(2)- (MAYTAG) TOP LOAD WASHER LID SWITCH KIT  
#12001908.

# Instruction Sheet

**REPAIR PART NO.:** 12001908 (MPN 6 2306250)

**DESCRIPTION:** LID SWITCH KIT

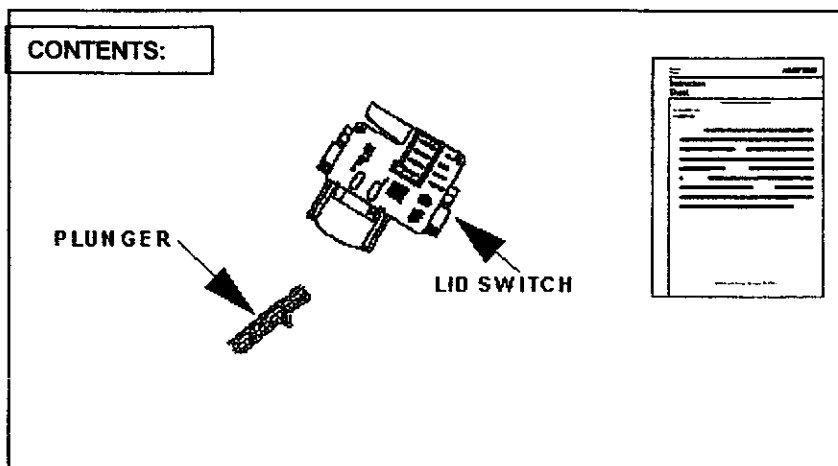
The purpose of this instruction is to inform you of changes made to the switch, making the switch no longer adjustable. The lid switch mechanism is designed to shut off the machine if the lid is lifted no more than 1-7/8" and will allow the machine to start when the lid is less than 1/4" high. The plunger is only used with Atlantis washers.

**Note:** The new lid switch (identified with a grey button) is now non-adjustable. You cannot adjust by pulling on the lid switch button.

**Atlantis washers:** In addition to the new lid switch, a change was also made to the length of the plunger.

1. Disconnect power.
2. Remove console to gain access to lid switch.
3. Lift lid slightly to remove pressure on the lid switch.
4. Remove lid switch and install new.
5. Reverse the afore mentioned steps.
6. Verify proper lid opening per measurements in the first paragraph.
7. If machine continues to not operate properly, please follow information shown on the following page.
